Access Compliance Report

Public Rights-of-Way

(Curb Ramps)

Intersection ID: 13056	Main Street: S_MINT_ST	Cross Street: W_BLAND_ST	Location: N
ADA ID: 1014E9032636	Ramp Type: PerpDiag	Initial Pass/Fail: Fail	Overall Compliance: No
Severity Score: 8.75			
Codes/Mitigation Info/Possible Solution		Field Measurements/Component Compliance

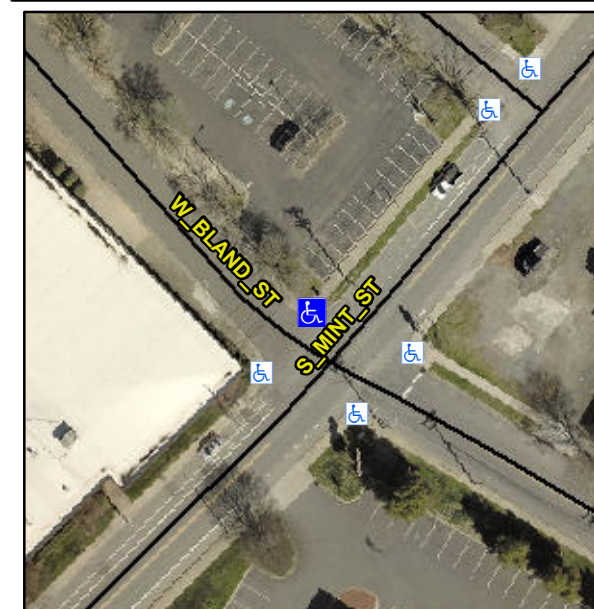
R304.5.1

Compliance	Description	Data	Compliance	Description	Data
N/A	Ramp Length (in)	54.0	Yes	Ramp Slope (%)	5.5
No	Ramp Width (in)	45.0	Yes	Ramp XSlope (%)	0.1
N/A	Flare Type LT	N/A	N/A	Flare Type RT	N/A
N/A	Flare Slope LT (%)	N/A	N/A	Flare Slope RT (%)	N/A
N/A	Flare Traversable LT?	N/A	N/A	Flare Traversable RT?	N/A
N/A	Landing Length (in)	N/A	N/A	DWS Provided?	N/A
N/A	Landing Width (in)	N/A	N/A	DWS Contrast?	N/A
N/A	Landing Slope (%)	N/A	N/A	DWS Length (in)	N/A
N/A	Landing X Slope (%)	N/A	N/A	DWS Full Width?	N/A
N/A	Landing Curb? (Y/N)	N/A	N/A	DWS Offset (in)	N/A
N/A	Shared Landing?	N/A			
N/A	Gutter Ponding?	N/A	N/A	Gutter Slope (%)	N/A
N/A	Gutter Lip Ht (in)	N/A	N/A	Gutter X Slope (%)	N/A
N/A	Painted X Walk1?	No	N/A	Painted X Walk2?	No
	X Walk 1 Direction	To SW		X Walk 2 Direction	To SE
N/A	X Walk 1 Width (in)	N/A	N/A	X Walk 2 Width (in)	N/A
	X Walk 1 Slope (%)	3.2		X Walk 2 Slope (%)	2.3
	X Walk 1 X Slope (%)	0.6		X Walk 2 X Slope (%)	1.4

Remove & Replace Curb Ramp With Two New Directional Ramps or Equivalent.
